Re: Third Five-Year Review, Former Castle Air Force Base, Atwater, California

Five-Year Review Report

Final
January 2009

SUBJECT: Change Pages, Five-Year Review Report for Castle Airport

**Estimated Plume Capture, Fourth Quarter 2007
Shallow Hydrostratigraphic Zone**

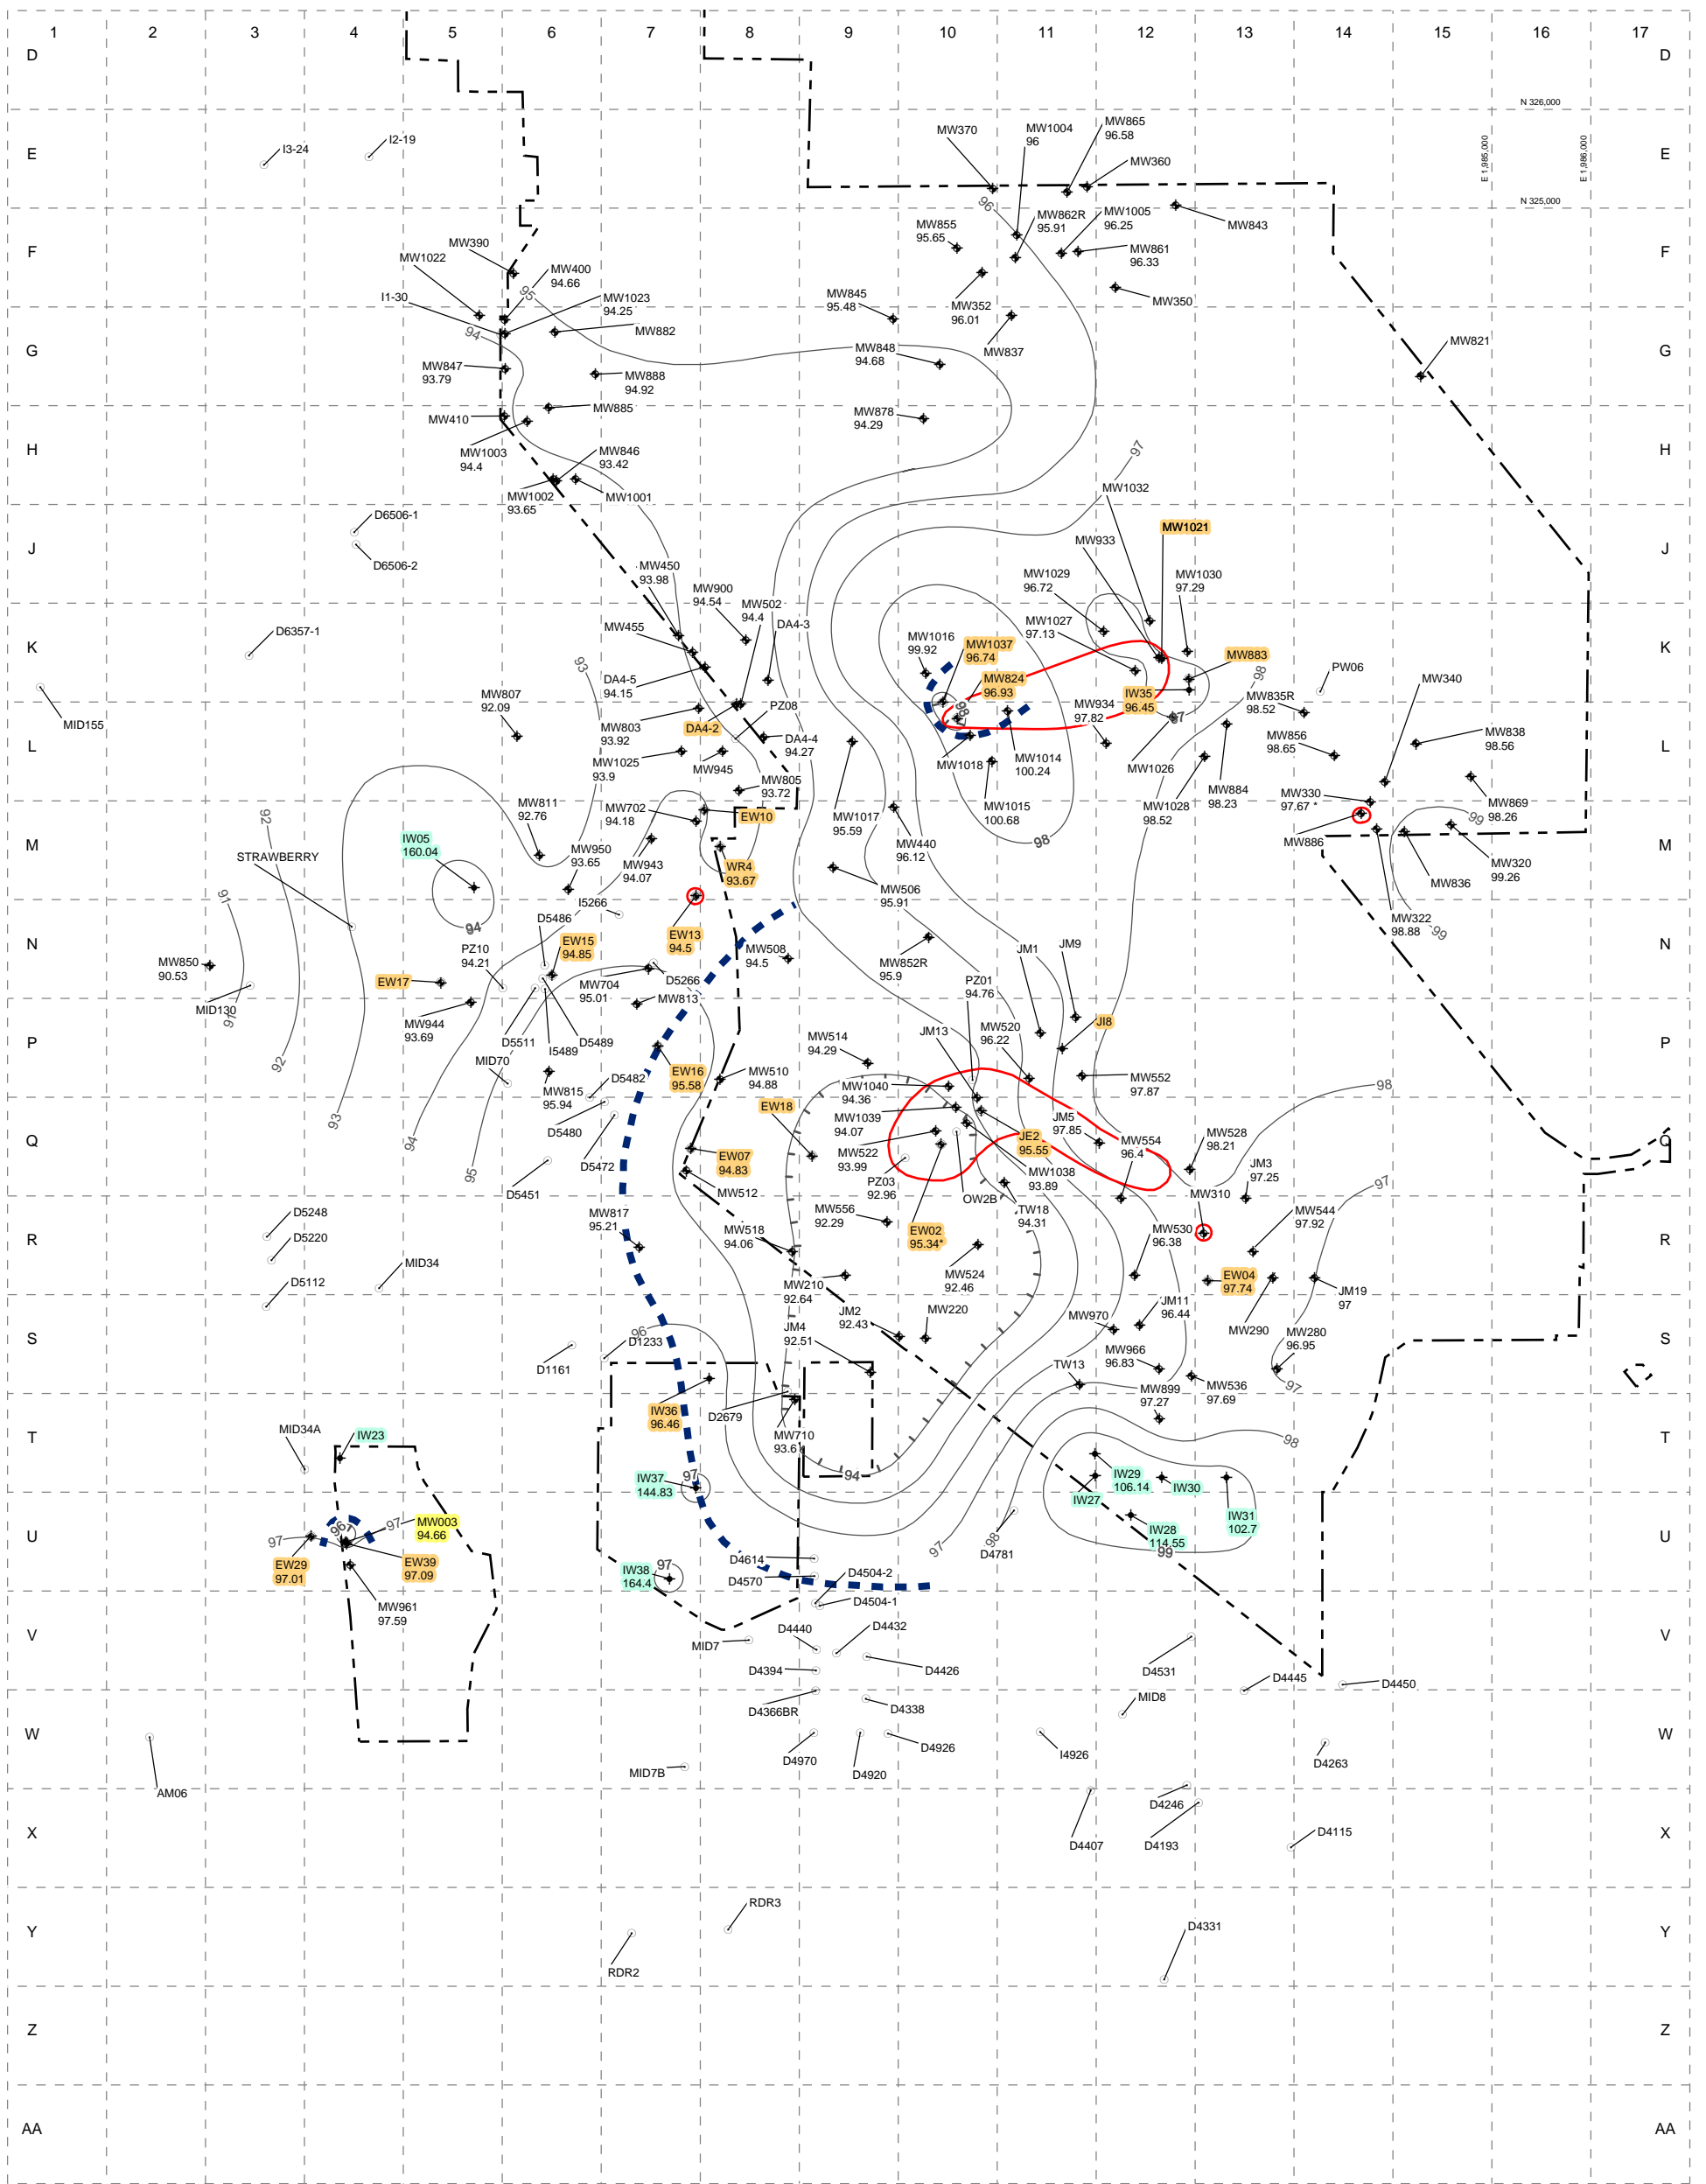
11. Section 7.1.1.1.2, Page 7-5: The last paragraph on this page concludes that the MCL plume is fully captured in the Shallow HSZ even though no extraction wells currently operate in this HSZ. While this may be true for the two larger main base plumes, the small plume centered on EW13 does not appear to be captured (see Figure 7-5). Explain this discrepancy.

Response: The text on page 7-6 has been revised to state that the small, intermittent MCL plume at EW13 is not subject to capture from pumping in the Shallow HSZ but does fall well within the estimated capture zone for the immediately underlying USS HSZ. Because of the small and intermittent nature of this plume segment and the fact that capture by pumping from the underlying HSZ is likely, the residual contamination at EW13 is not seen as a significant issue. The reported TCE concentration at EW13 last exceeded 10 µg/L in Q1/00. The reported TCE concentration of 5.5 µg/L shown on Figure 7-1 was from a January 2007 sample (well sampled annually). A special sample collected in May 2007 had a reported TCE concentration of 3.2 µg/L. Since 2005, the reported TCE concentration at EW13 has ranged from ND to 7.3 µg/L.

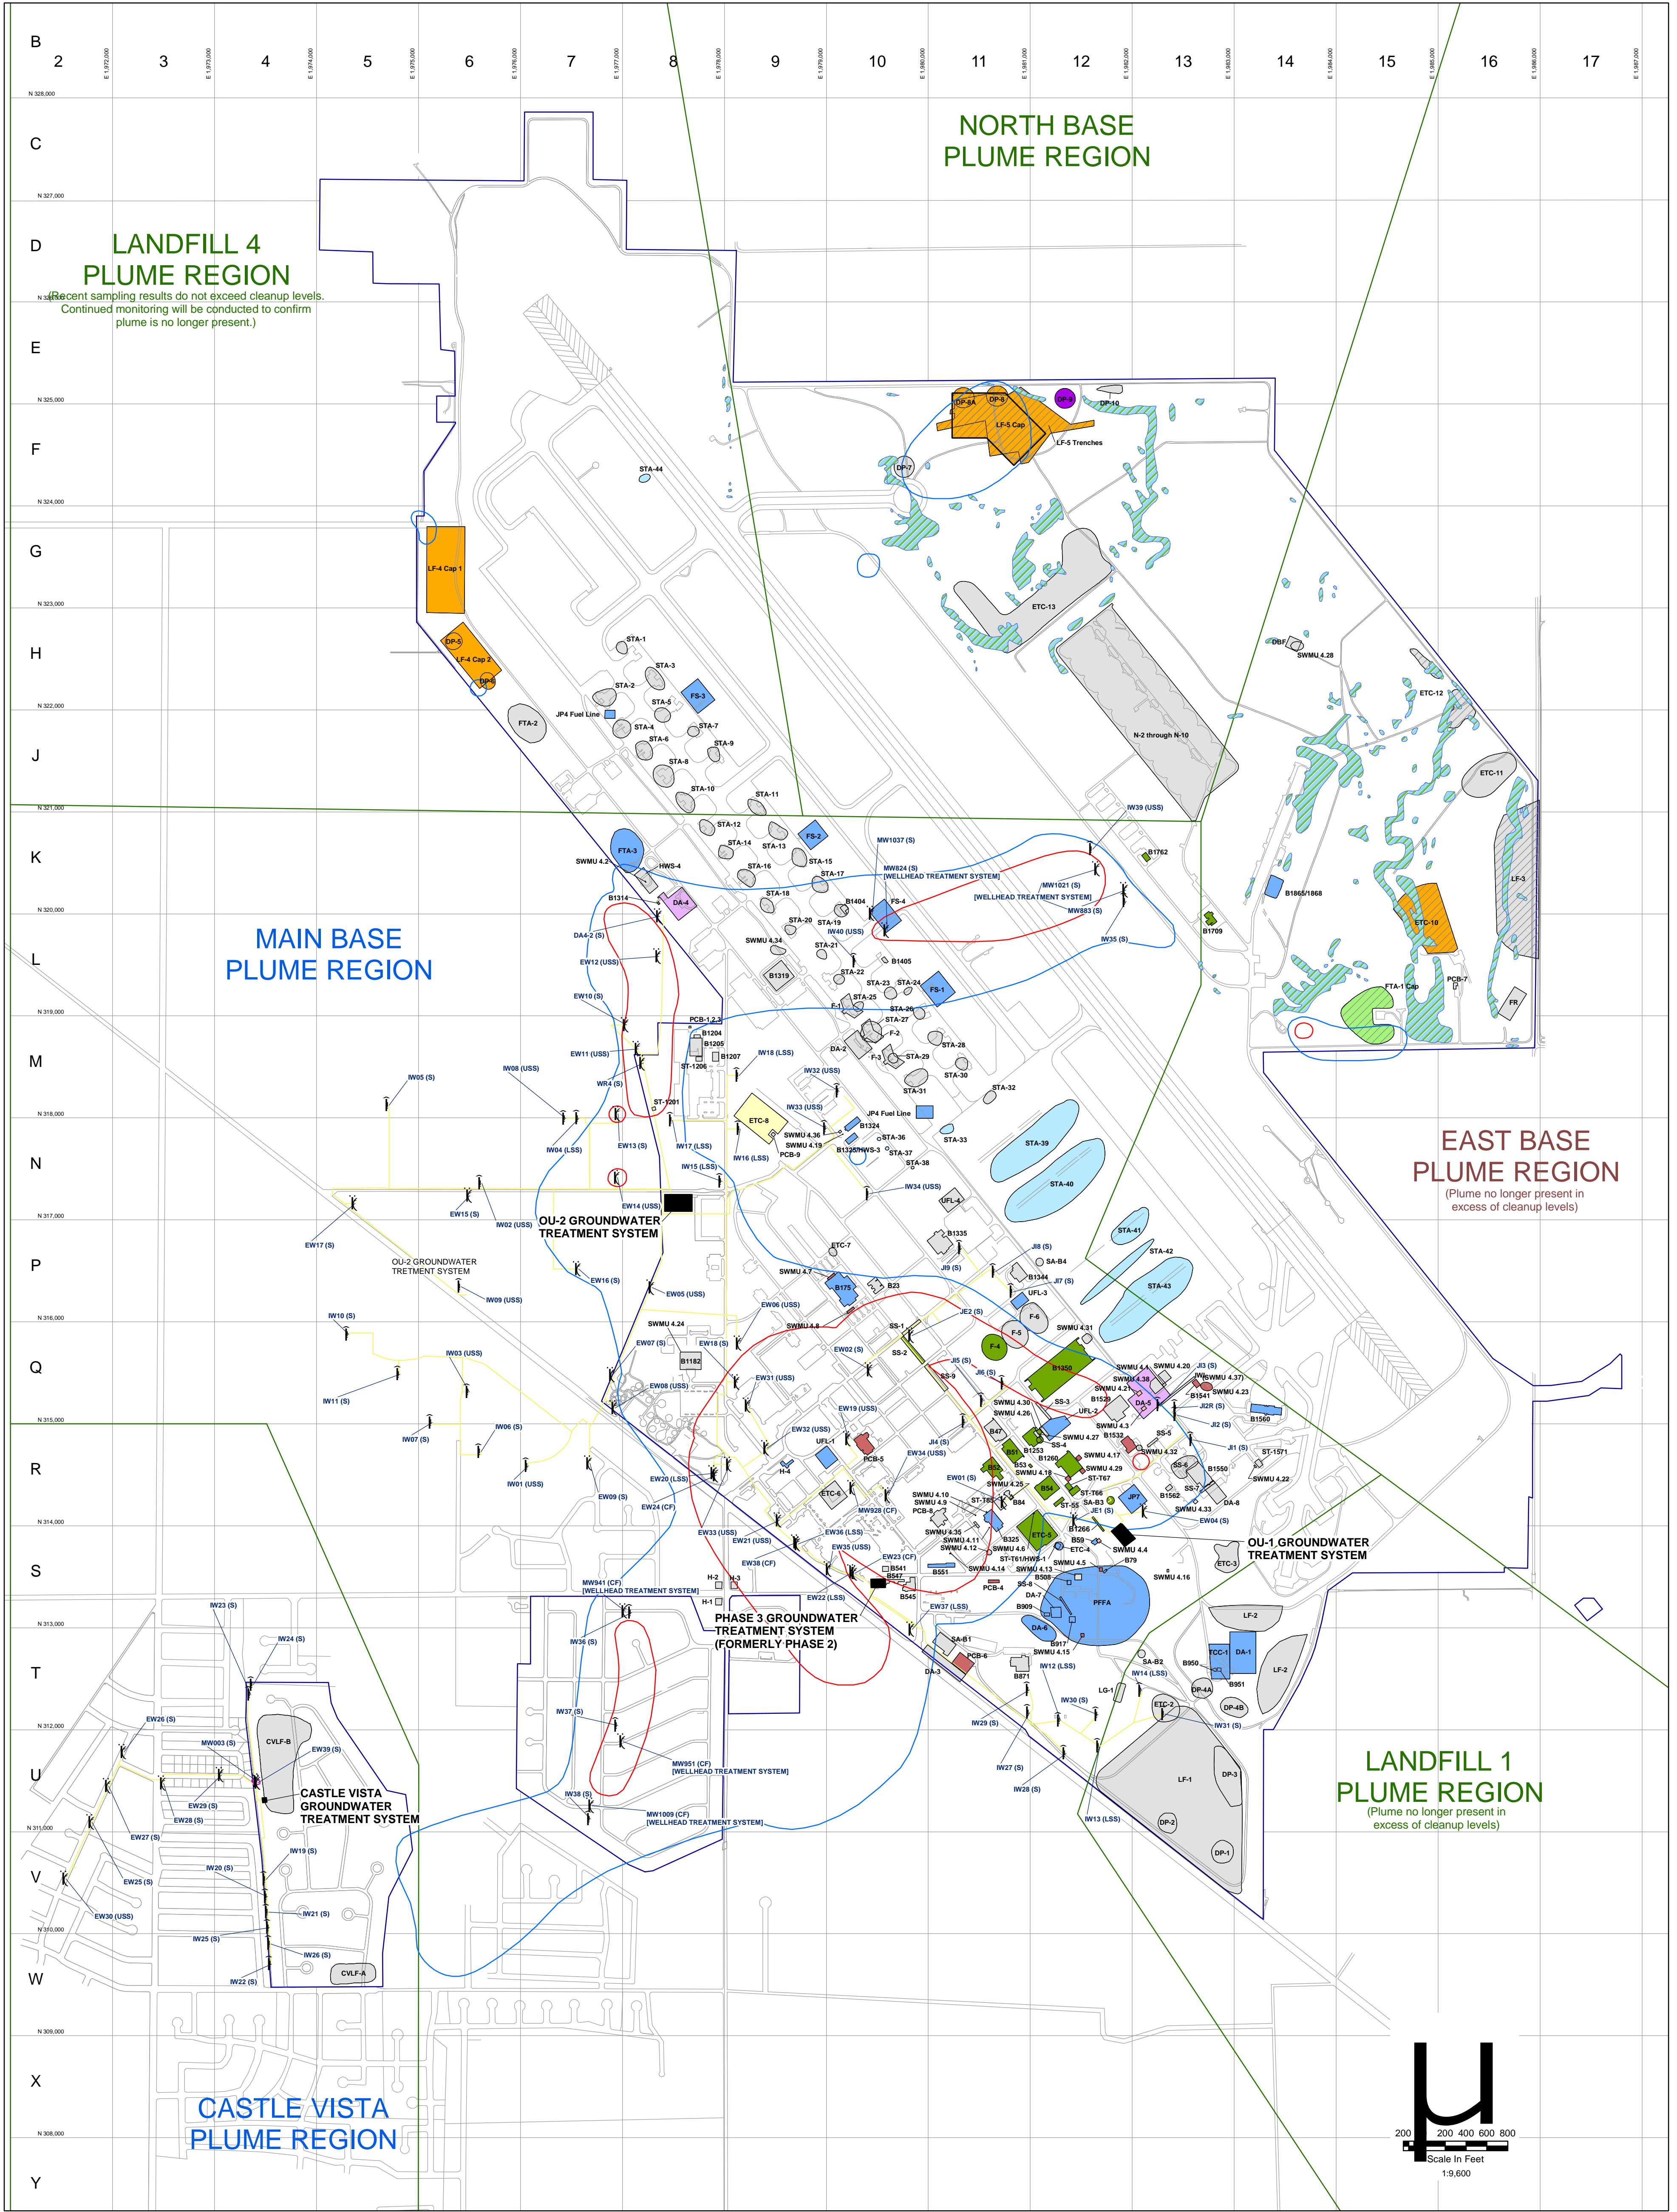
16. Plate 1: Please add the 0.5 µg/L contour for each groundwater plume depicted on this figure.

Response: Concur. The “combined” 0.5 µg/L TCE contour has been added to Plate 1.
